UNITED STATES PATENT AND TRADEMARK OFFICE

| 10/730,834 | 12/08/2003 | Nick Kuo | JCLA11759 | 5204 |

Office Action Summary

DETAILED ACTION

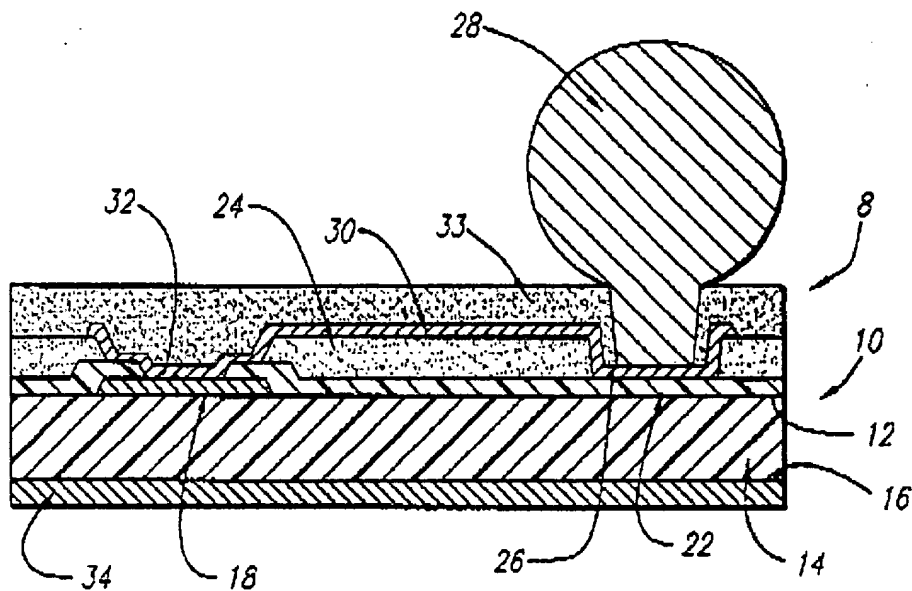
4. Claims 1, 3, 8-11, 13, 17, 19, 20, 25 and 26 are rejected under 35 U.S.C. 103(a) as being unpatentable over Elenius et al. (US 6,287,893) in view of Kim (US 5,854,513) further in view of Sato et al. (US 4,051,508).

5. Regarding claims 1 and 3, Elenius (e.g. figs. 1 & 2) shows a substrate 14, a metallization structure 18 over the semiconductor substrate; a passivation layer 22 over the metallization structure 18, wherein an opening in the passivation layer exposes a top surface of the metallization structure and a patterned circuit 30 connected to the top

surface though the opening, wherein the patterned circuit layer comprises a first portion having a bump 28 formed thereover and a second portion connected to the first portion (col. 1/lls. 22-45 & col. 6/lls. 1-37).

Elenius does not teach a testing pad or second portion used to be in contact with a testing probe and/or a patterned circuit layer comprising a gold layer. Therefore, Elenius in view of Kim does not teach that the gold layer has a thickness greater than one micron. Nevertheless, Kim (e.g. fig. 3) shows a patterned circuit layer connected to a top surface though an opening wherein the patterned circuit layer comprises a first portion used to have a bump 27 formed thereover and a second portion to be in contact with a testing probe whereon the first portion is connected to the second portion. This type of embodiment prevents decreases in testing reliability caused by damages on the surface of the bump and polluting material thereby enhancing its yield with respect to bonding (col. 2/lls. 10-30).

FIG.3

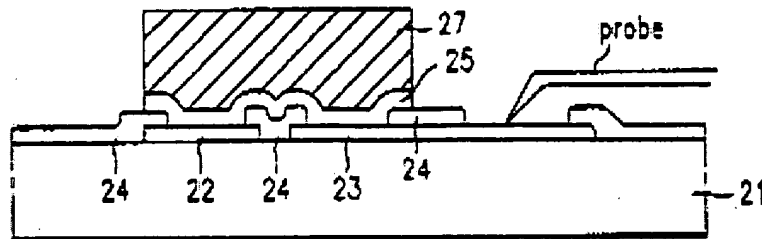
On the other hand, Sato teaches that pattern circuit layer comprising a gold layer of 2 microns (col. 34/35). It would have been obvious to one of ordinary skill in the art at the time the invention was made to include a second portion used to be in contact with a probe to prevent decreases in testing reliability caused by damages on the surface of the bump and polluting material during the testing process, thereby enhancing its yield with respect to bonding as taught by Kim and to make the pattern circuit layer disclosed by Elenius in view of Kim comprising gold layer of 2 microns as suggested by Sato to increase the electrical conductivity of the patterned circuit layer and because it has been held to be within the general skill of a worker in the art to select a known material on the basis of its suitability for the intended use as a matter of obvious design choice. In re Leshin, 125 USPQ 416
